Proposal #06: 5289-00-71
STH 82 – CTH Y
W Fork Kickapoo Br B-62-0245
CTH S
Vernon County

This is Addendum No. 02, which provides for the following:

ADDENDUM NO. 02

ACCEPTED
STRUCTURE B-62-245
 CTH'S OVER WEST FORK KICKAPOO RIVER
 COUNTY VERNON TOWNSHIP WEBSTER
 DESIGN SPEC. 100 LBS. BRIDGE DESIGN SPECIFICATIONS
 DESIGNED BY ATG EXT. TIP DAMAN MIT PAVS
 BY ATG EXT. TIP DAMAN MIT PAVS
 DATE

GENERAL PLAN
 SHEET 1 OF 14
 51

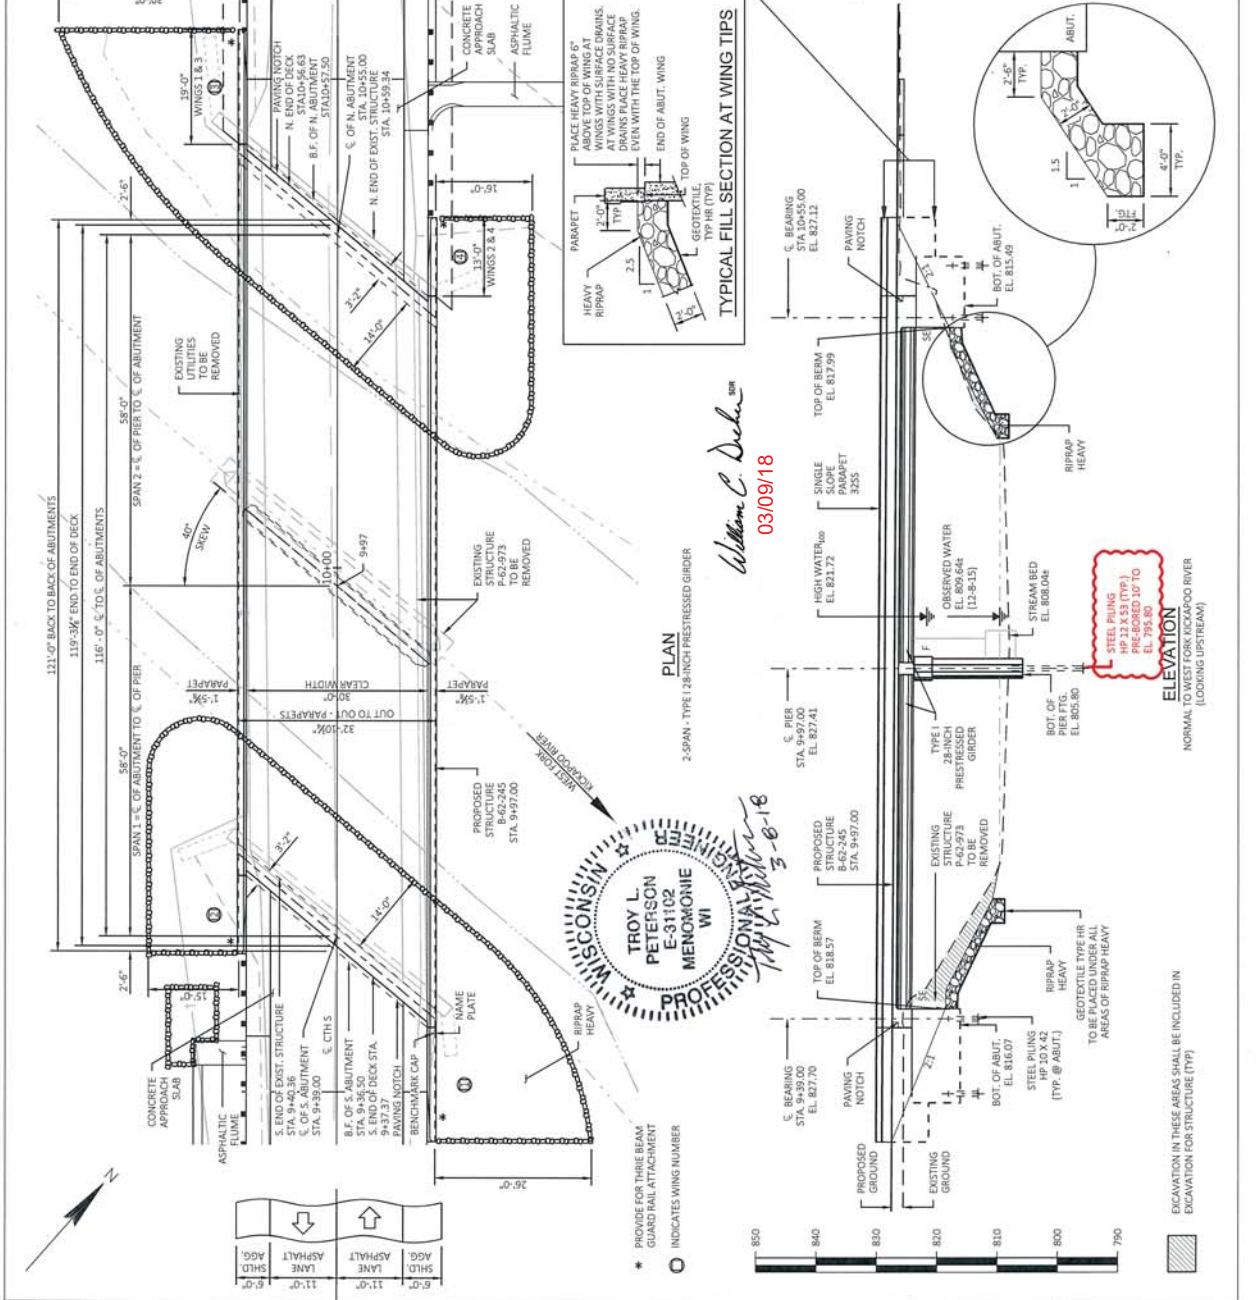
Revised Plan Sheets	
Plan Sheet	Plan Sheet Title (brief description of changes to sheet)
51	Changed preboring elevation in elevation; Changed estimated pile length in foundation data
52	Total Estimated Quantities; Revised Piling Steel HP 10-Inch x 42 LB quantity

VELOCITY - THRU STRUCTURE	1.130 C.F.S.	VELOCITY - THRU ABUTMENT	3.807 C.F.S.
VELOCITY - THRU ABUTMENT	3.807 C.F.S.	HIGH WATER ELEVATION	814.05 FT.
TRAFFIC DATA			
AADT (2018)	520	DESIGN SPEED	55 M.P.H.
ADAD (2018)	630	DESIGN SPEED	55 M.P.H.
FOUNDATION DATA ABUTMENTS TO BE SUPPORTED ON PILING STEEL HP 10 X 42, WITH A REQUIRED DRIVING RESISTANCE OF 180 TONS PER PILE AS DETERMINED BY THE MODIFIED GATES DYNAMIC EQUATION. PILING POINTS ARE REQUIRED.			
ESTIMATED LENGTH 15' SOUTH ABUTMENT ESTIMATED LENGTH 15' NORTH ABUTMENT PILES TO BE SUPPORTED ON PILING STEEL HP 13 X 53, PLACE PILES INTO PRE-BORED HOLES. PILES PLACED IN PRE-BORED HOLES BORED INTO ROCK DO NOT REQUIRE DRIVING.			
ESTIMATED LENGTH 15' PIER THE FACTORED AXIAL RESISTANCE OF PILES IN COMPRESSION USED FOR DESIGN IS THE REQUIRED DRIVING RESISTANCE MULTIPLIED BY A RESISTANCE FACTOR OF 0.5 USING MODIFIED GATES TO DETERMINE DRIVEN PILE CAPACITY.
